**DEVIATION REQUEST  
AND DECISION FORM**

Project Name : Iron Ridge Subdivision  
 Schedule No.(s) : 6100000457 & 6100000439  
 Legal Description : Portion of SE ¼ of Sect. 13, Township 11 S, Range 66 W of the 6<sup>th</sup> Principal Meridian, El Paso County, CO

# IRON RIDGE

## VARIANCE REQUEST

VARIANCE REQUEST	
IRON RIDGE	
JOB NO. 25009	
LOCATION: EPC	
09/17/2025	
SHEET	1

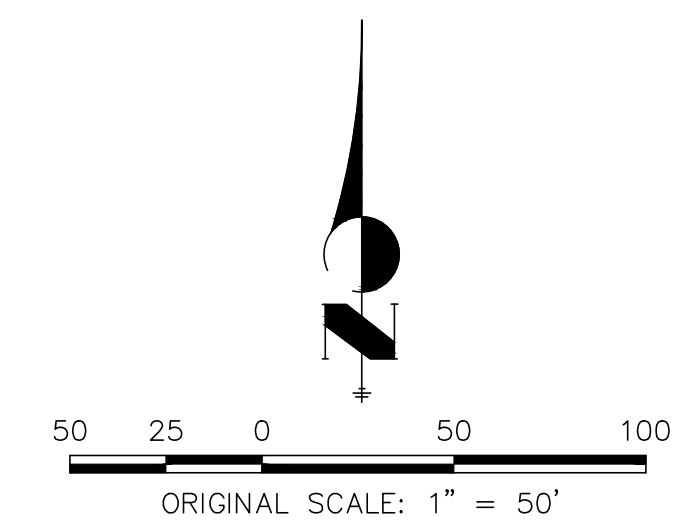
Engineering Criteria Manual – Section 2.3.3.F.3 Broken Back curves - I.7.1.C.1.A - Two curves in the same direction (broken back curves) shall be separated by a tangent with a length of at least two times the minimum length shown in Table 2-10. For local roadways, a minimum tangent of 200 feet shall be used to separate all broken back curves.

The deviation is being requested to reduce the lot and roadway area within the site's existing geologic hazards and constraints. The geologic hazards and constraints include artificial fill, potentially expansive soils, downslope creep, potentially unstable slopes, shallow bedrock, seasonal and potentially seasonal shallow groundwater areas, areas of ponded water, erosion, and the potential for elevated radon levels. The roadway design intention is to limit the roadway area within the geologic hazards. Given the site's existing topography, location of existing Brown Road and the geologic hazards, Iron Ridge Court is severely constrained and a deviation from broken back length standard allows the road to avoid significant impact to geologic hazard areas. Furthermore, the site's existing topography is very severe, with some slopes exceeding 50%. This topography makes it challenging to design a roadway meeting EPC ECM slope and vertical curve criteria while still leaving 'buildable' lot areas, when considering geologic hazards as well. By reducing the broken back curve length, Iron Ridge Court can meet other EPC ECM criteria.

The proposed alternative requests the 200' distance to be reduced to 135' for Iron Ridge Court. While the EPC ECM doesn't provide additional commentary regarding broken back curves, CDOT provides additional guidance. According to CDOT, Roadway Design Guide Section 6.3.4.6 "the broken back" arrangement of curves should be avoided except where very unusual topography or right of way conditions make other alternatives impractical." Due to the topography constraints explained above and the ROW constraints due to the location of existing Brown Road, which Iron Ridge Court must line up with, I believe this site qualifies for a reduction of the criteria.

If the broken back curve on Iron Ridge Court is replaced with a single curve with a radius of 300' (per EPC ECM criteria for rural local roadways), Iron Ridge Court would be pushed so far east that it would not be possible to plat lots on the east side of the road, due to the proximity of unnamed tributary to East Cherry Creek that will be platted as a no build easement. Since Iron Ridge Court is a dead end and only serves the 14 home sites located on it, it would not provide any benefit to the public to uphold this standard. The required site distance at Iron Ridge Court and Walker Road is not impacted by this variance. A reduction in posted speed is not required because of this variance. At a speed of 25 mph or ~37 ft/sec, a driver would have approximately 3.6 seconds from the exit of the 1<sup>st</sup> curve before the beginning of the 2<sup>nd</sup> curve. 3.75 seconds is adequate reaction time for the driver given there are no intersections along this stretch of roadway.

The deviation will not adversely affect the safety of Iron Ridge Court. With a posted speed of 25 mph and 135' between the broken back curve, a driver would have 3.75 seconds from the exit of the 1<sup>st</sup> curve to the beginning of the 2<sup>nd</sup> curve. The average reaction time for a driver is 2.5 seconds and therefore has adequate time to prepare for the 2<sup>nd</sup> curve.

This request has been determined to have met the criteria for approval. A deviation from Section 2.3.3.F.3 of the DCM is hereby granted based on the justification provided.

Project No.: 25193  
September 19, 2025  
Sheet 3 of 3

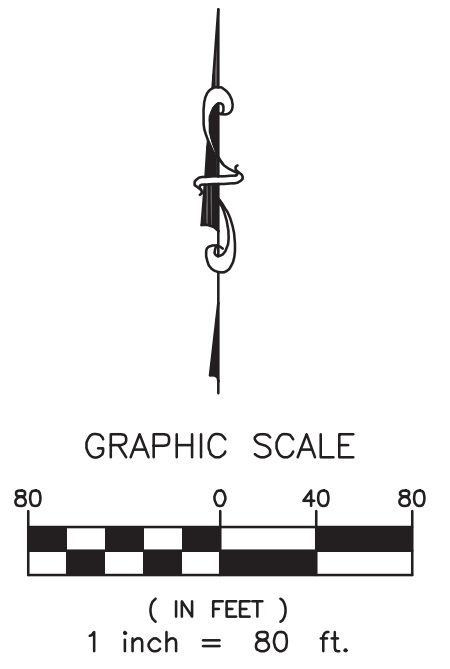
The Monument Fire District has reviewed the project and were asked the specific question: Does the extension of Colt Court meet fire department requirements.

- The Colt Court extension is approximately 1500' long (individual property driveways may be considered to meet intermediate turnaround requirements)
- The Colt Court driving surface is 60' wide
- The Colt Court cul-du-sac has 120' diameter

These dimensions are acceptable to the District.
